MANDATORY SERVICE BULLETIN Z 142/40a, Z 43/39a

- 3. SUBJECT:** Possibility of passage loss through the hose connected to the Pitot-static probe caused by excessive deformation of this hose and resulting in the malfunction of the speed measuring system.

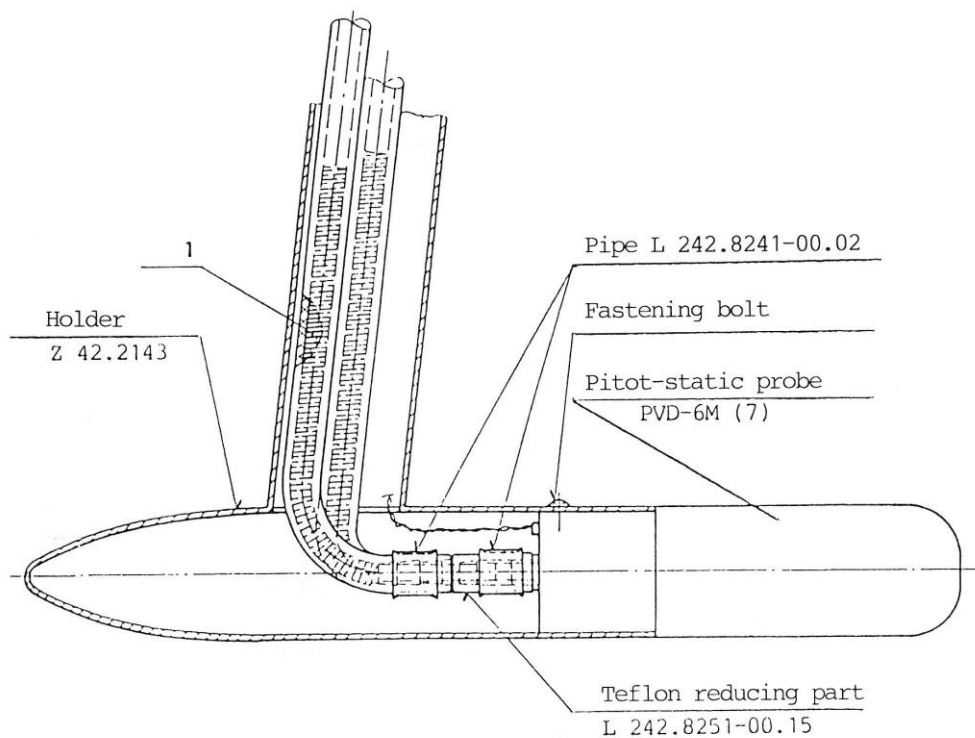
2. Slip the inlet hoses of Pitot and static pressure out of the teflon reducing parts. Insert the distance spirals L 242.8251-00.14 (pos. 1) inside both the hoses. The hoses connect back to the teflon distance pieces struck on the probe.

- 7. PROCEDURE:**
1. Unscrew the three bolts fastening the Pitot-static probe, slip the probe out of the holder (at the same time loosen the inlet hoses from the other side of the holder).

3. Slide the Pitot-static probe back into the holder carefully pulling the inlet hoses step by step from the other end of the holder at the same time. Screw the three bolts fastening the Pitot-static probe.

4. Check the leakage of the Pitot-static system.
